Fire Management Report for Development of ERF 3122 - Hartenbos

Annexure 2: Fire constraints map

Annexure 3: Development proposal and fire scoping comments

Annexure 3: Development proposal (2017) and fire scoping comments

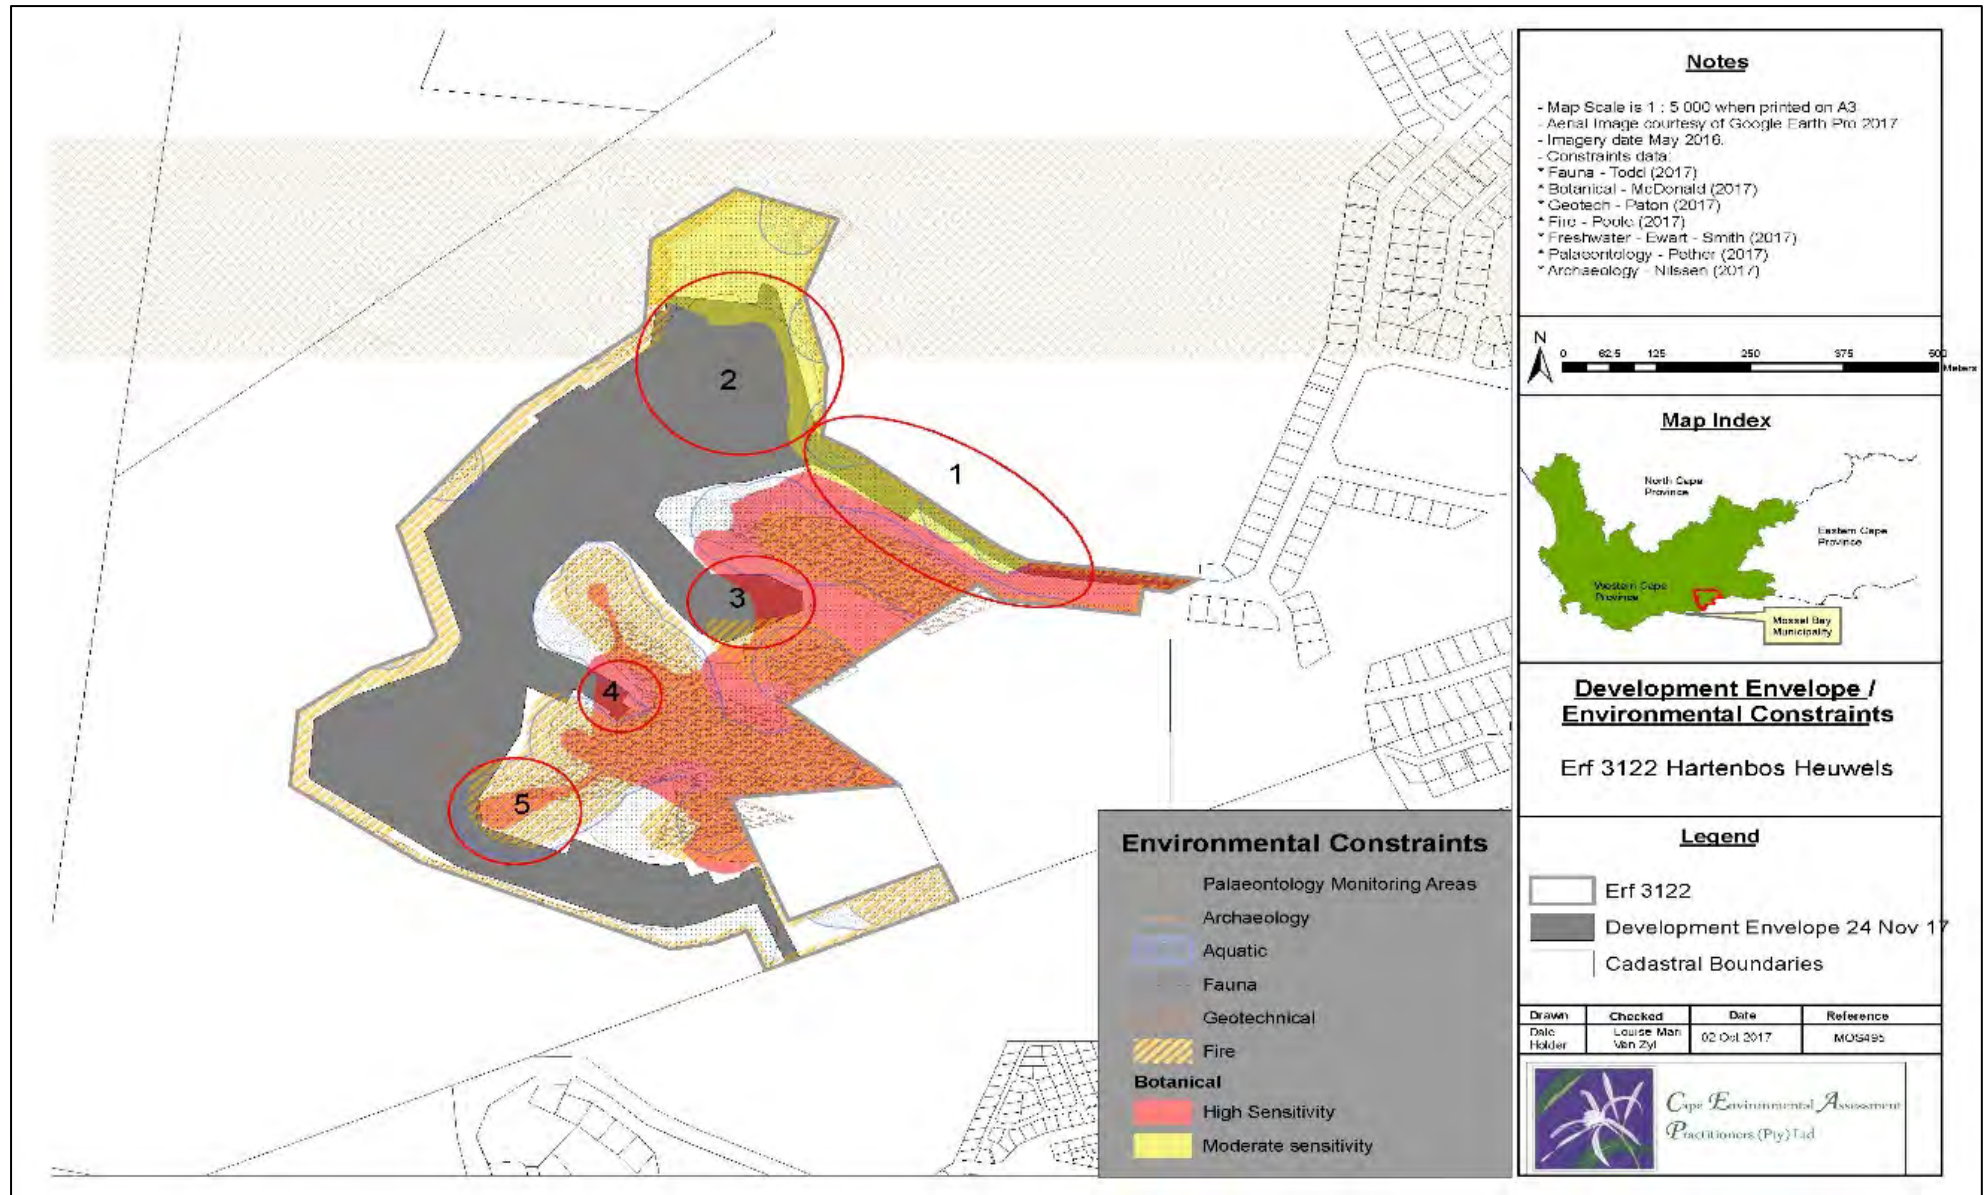
AREA	SPECIALIST	COMMENT
1	Fire	Changes acceptable.
2	Fire	<p>Changes acceptable. Not technically in zone 2 but... erfs 24, and 29 -32 can be safely enlarged to similar proportions as erfs 25 – 28.</p> 
3	Fire	Changes acceptable.
4	Fire	<p>Changes acceptable with the following additional mitigation measures: Erf 139 should be reduced to half its size as it is situated on a high risk area at the mouth of the drainage.</p>  <p>Structures on erfs 140 -143 should be placed on the side of the erf that is the furthest from the drainage to create defensible space should a fire burn into the drainage (This should be the general practice for all erfs bordering flammable material).</p>
5	Fire	Changes acceptable.

Annexure 5: Revised development proposal dated 27 February 2018

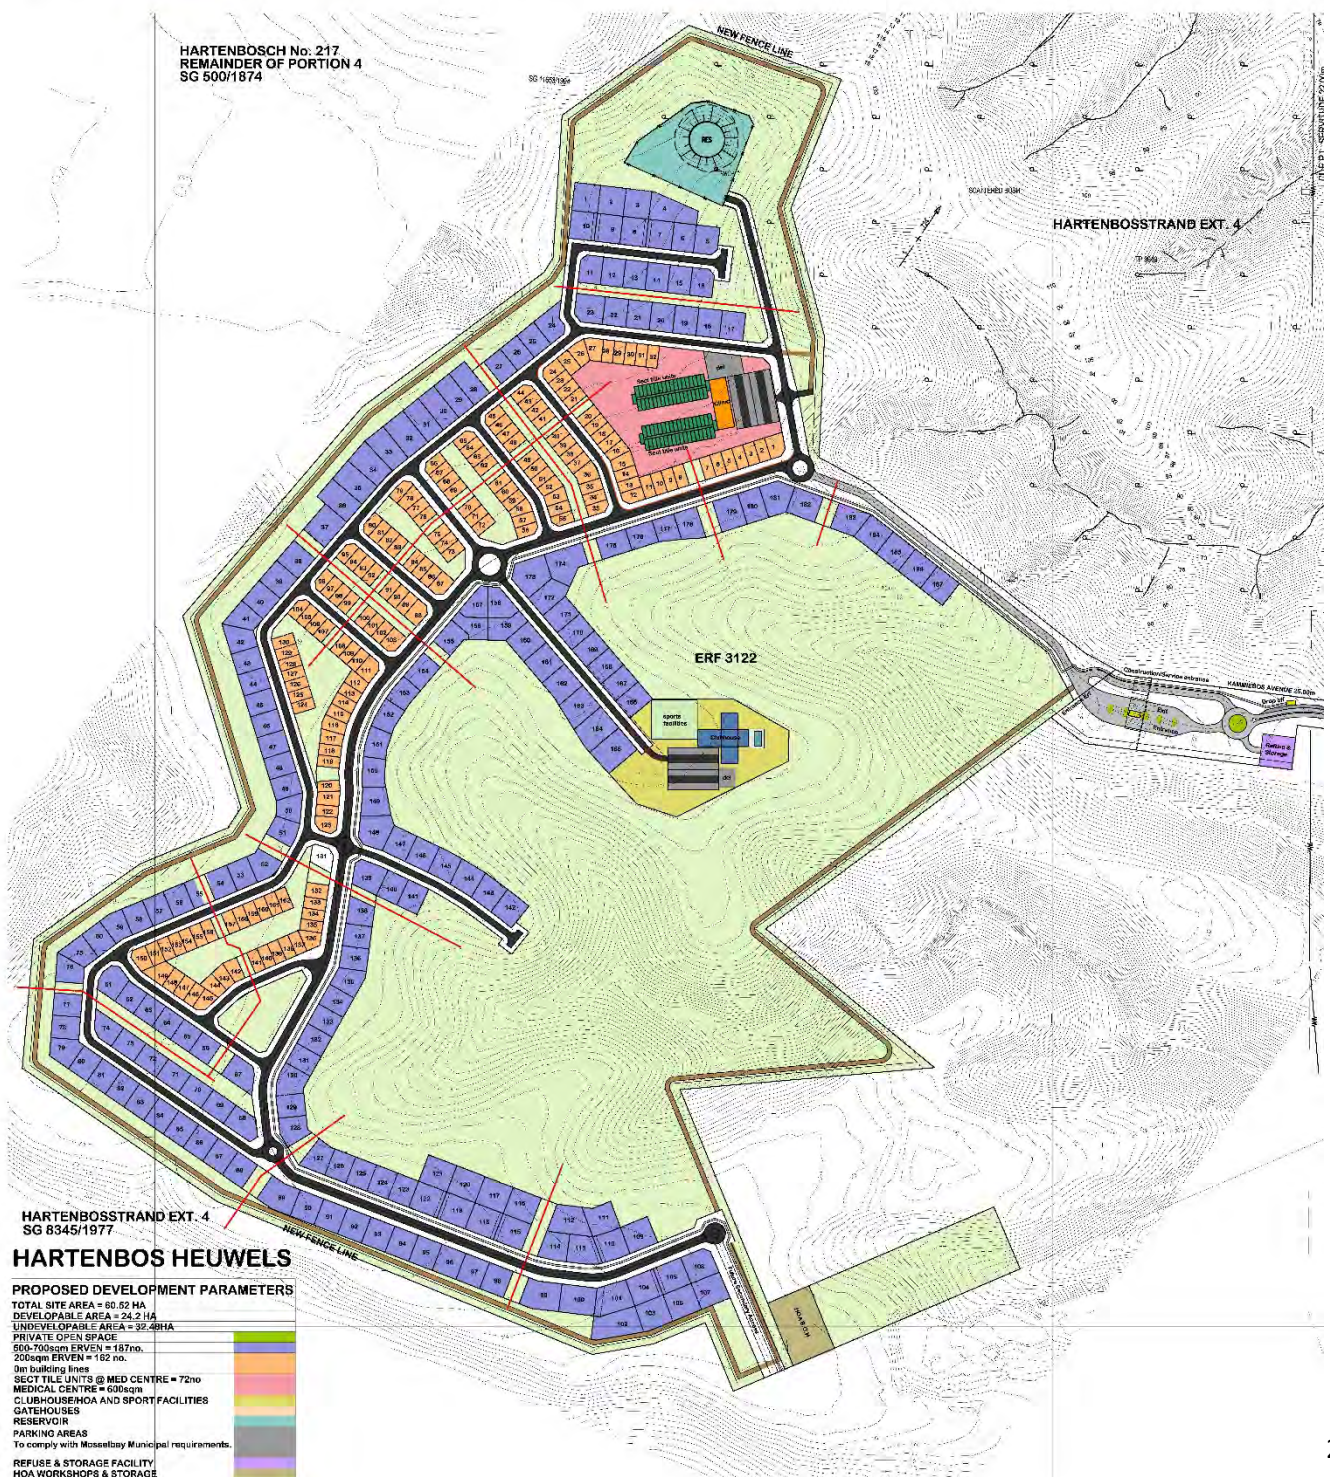
- 9.5. On 28 February a new proposed layout dated 27 February 2018 (Annexure 5) was received. The main changes were highlighted as follow:
- 9.5.1. Erven 1 – 4 in the far north have been moved closer to the reservoir (the space used to be open). There is no additional fire risk associated with this change;

- 9.5.2. Erven 102, 103, 106 & 107 have been introduced at the southern exit (the space used to be open) There is no additional fire risk associated with this change;

- 9.5.3. There are some minor changes to some ‘internal erven’ that were of the larger type (500-700sq/m) that are now of the smaller type 200sq/m. There is no additional fire risk associated with this change.

- 9.5.4. There are additional open space linkages built into the revised plan that can be seen with the red lines. These changes are beneficial from a fire management perspective since it provides access and additional area that can be used for defensible space.

- 9.6. The authors are satisfied that the revised layout dated 27 February 2018 (Annexure 5) is safe for development from a fire management perspective. This layout adequately addresses all of the fire management concerns previously raised.

Annexure 6: Revised development proposal dated 03 March 2020

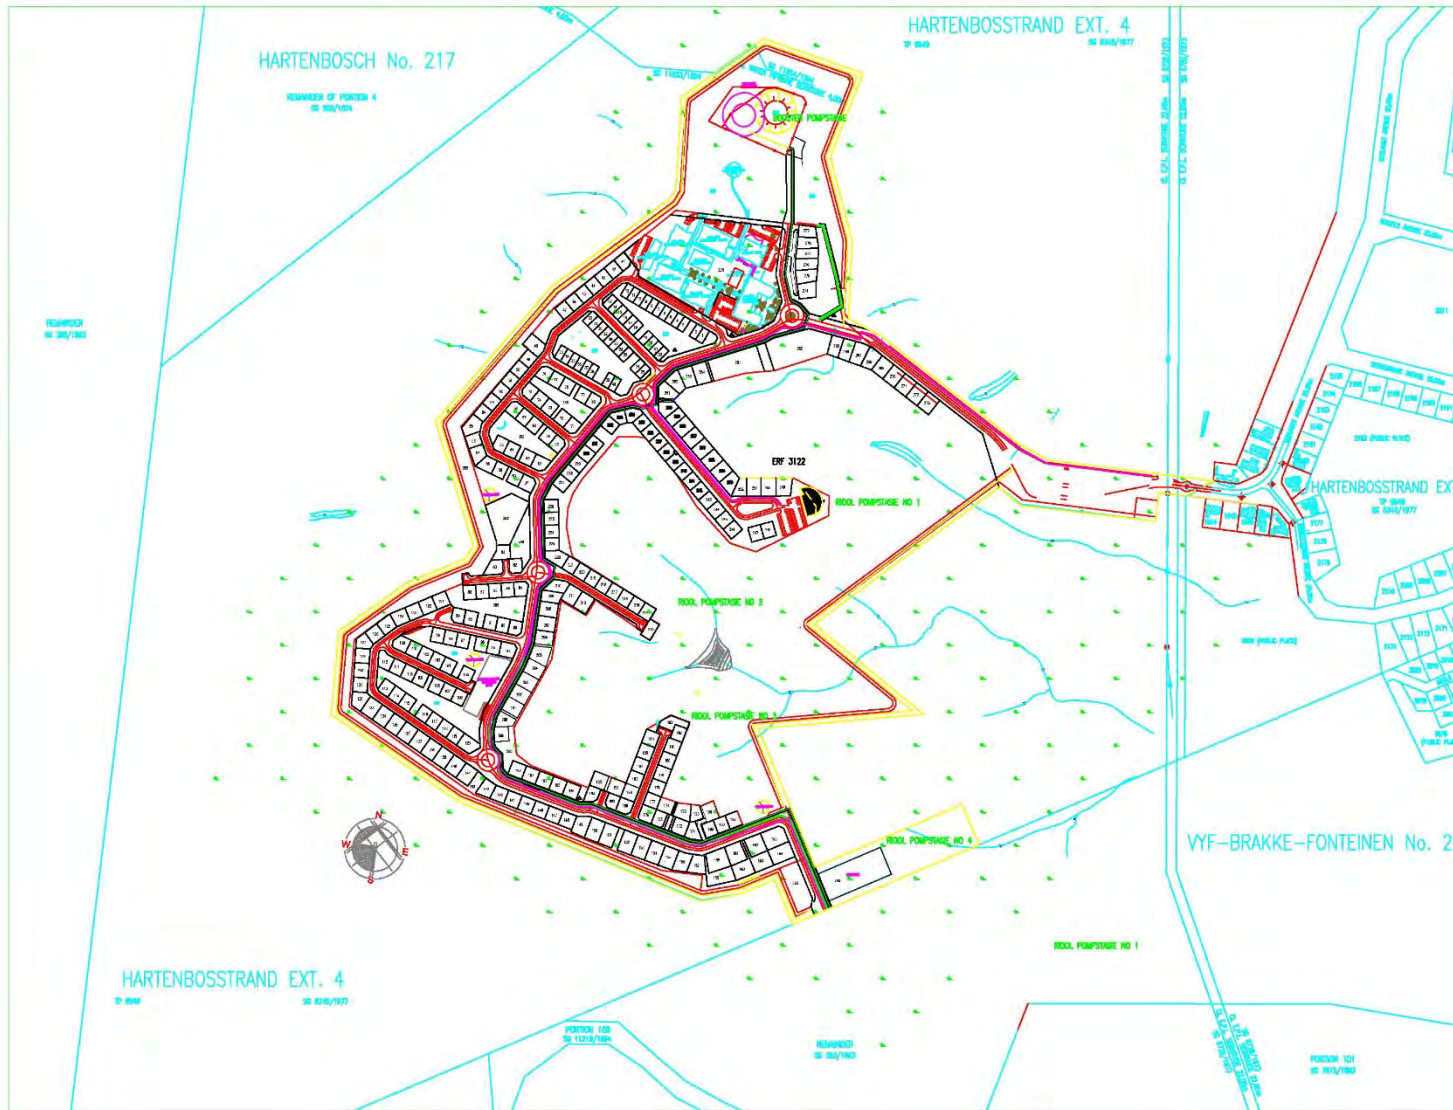
9.9. After careful consideration, the authors are satisfied that the revised layouts (Annexure 6, 7, 8, 9 & 10) do not exceed any of the constraints set from a fire management perspective. The proposed layouts therefore meet the approval of the authors.

Annexure 9: Revised development proposal dated November 2021

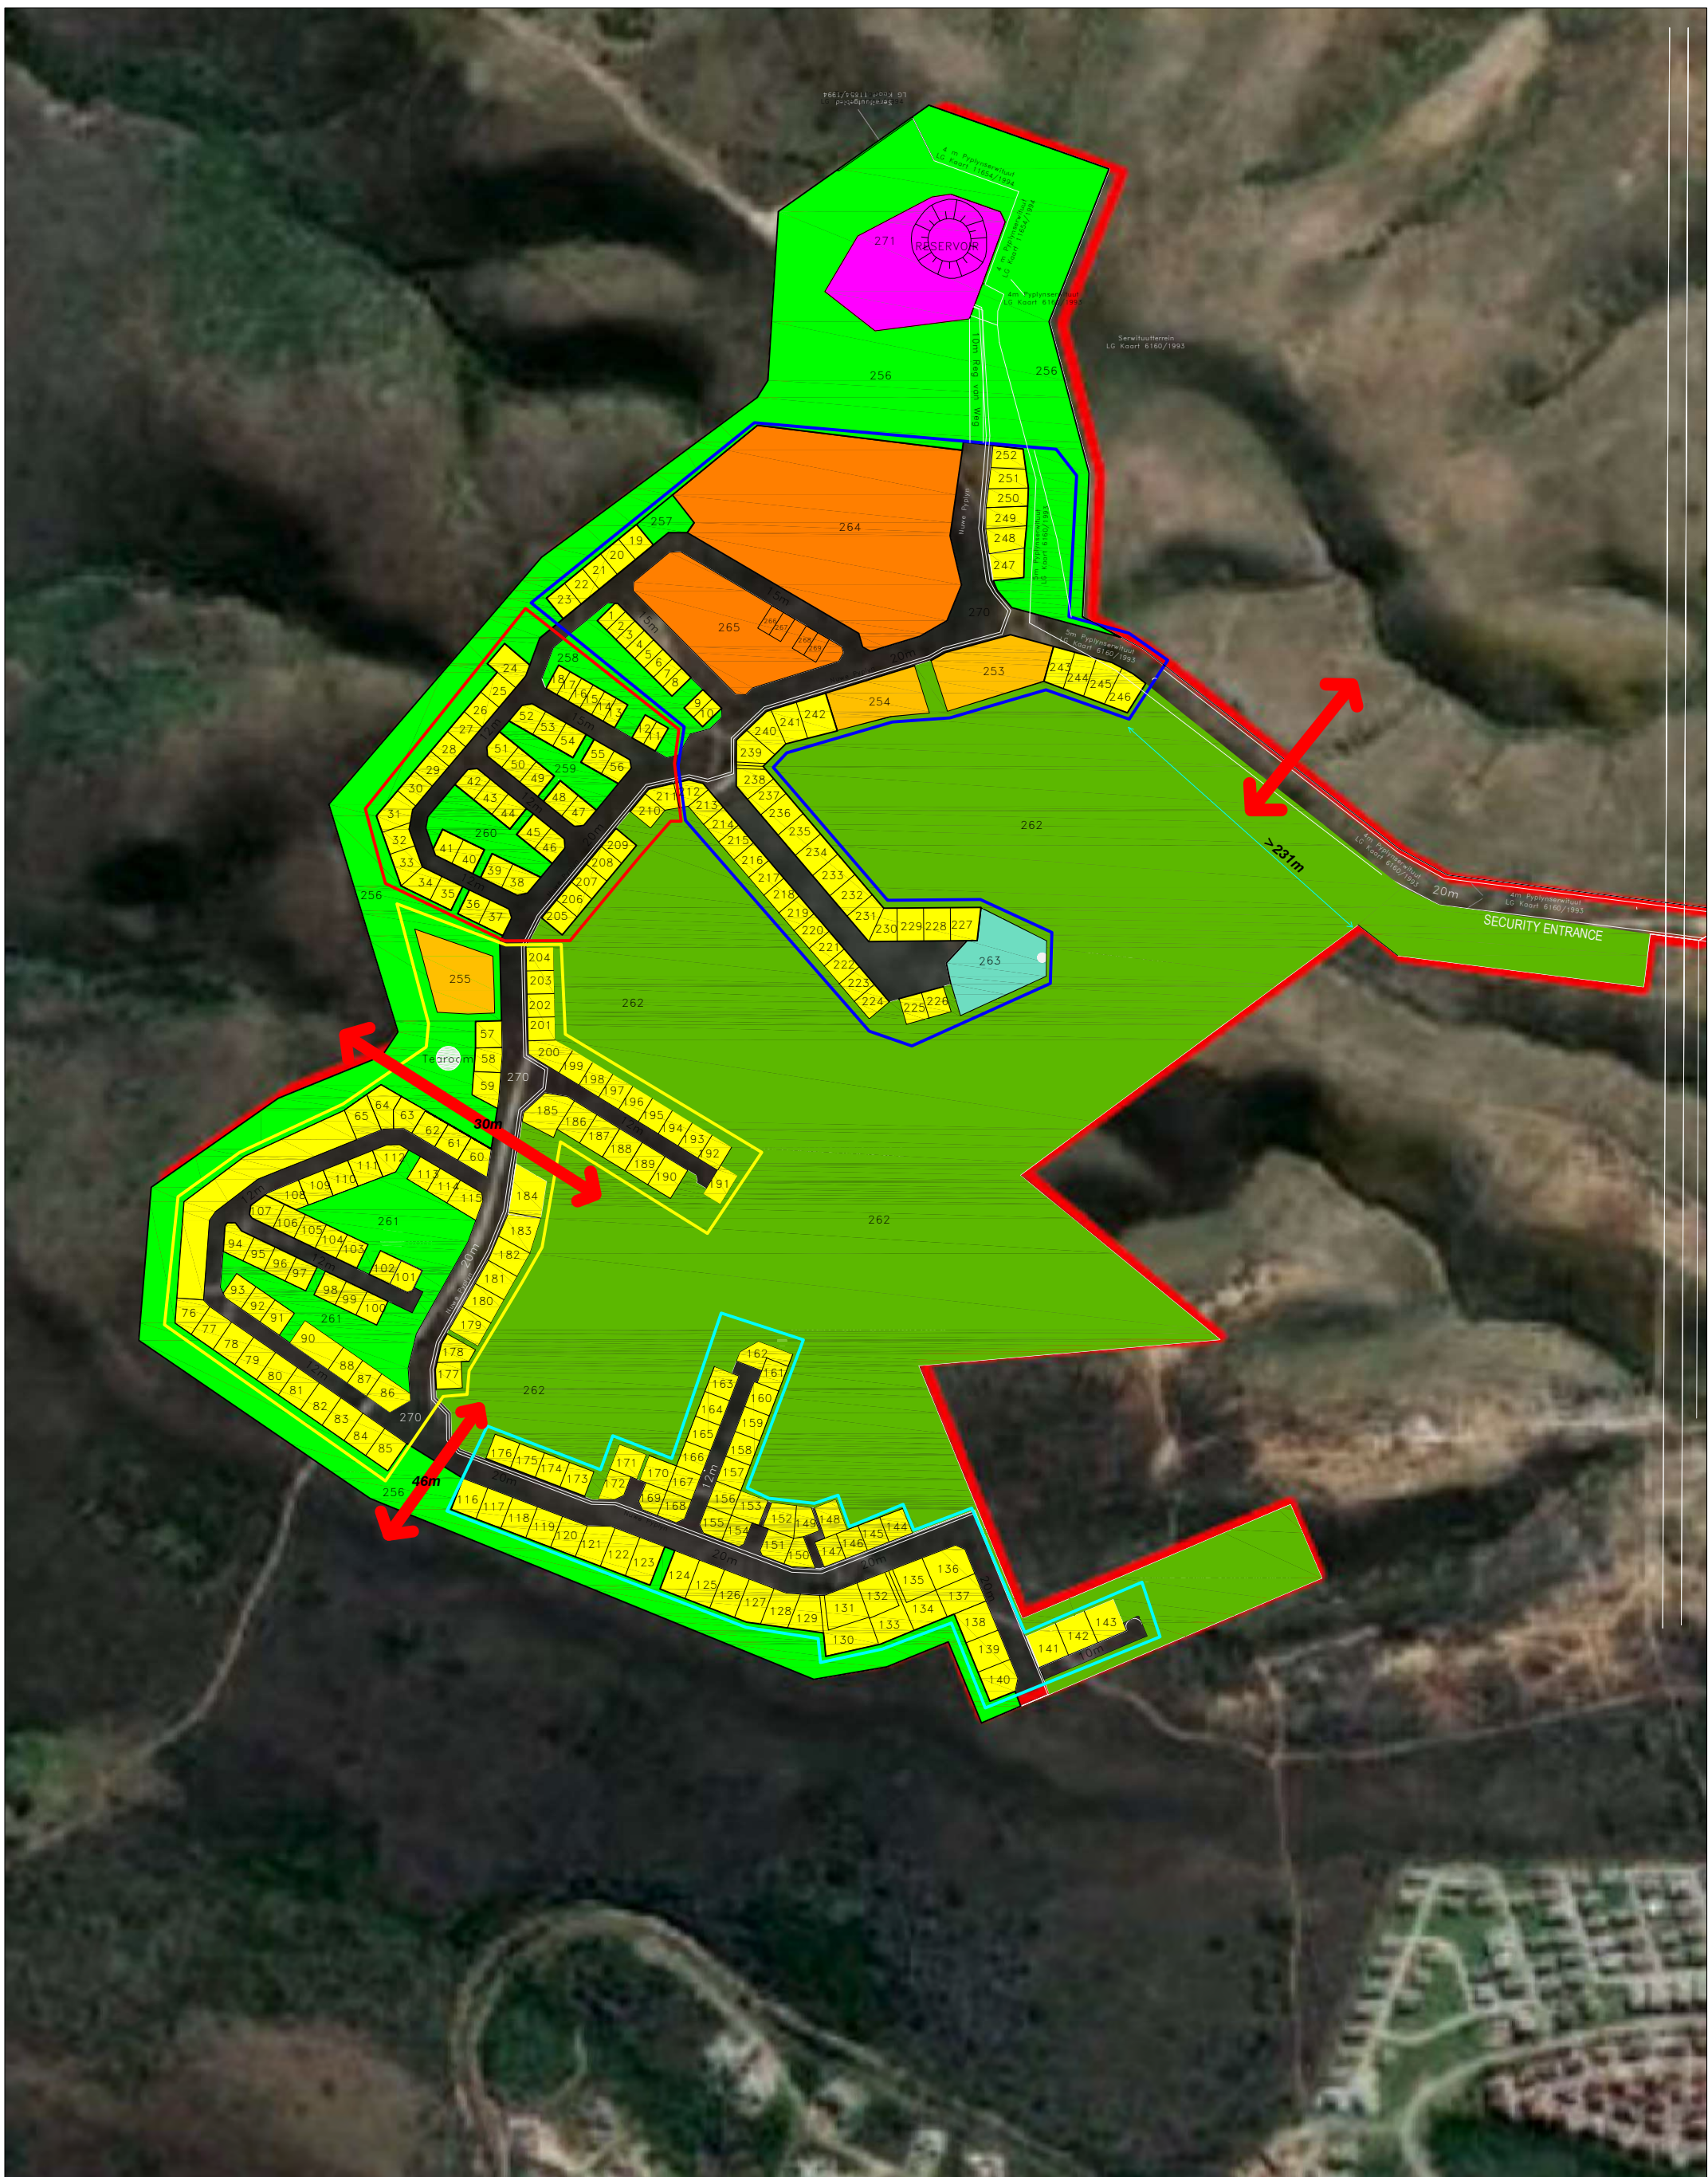
- 9.8. Likewise, two more alternative entitled “alternative 2” and “alternative 3” (Annexure 9 & 10) dated November 2021 and October 2022 respectively have been submitted for consideration.
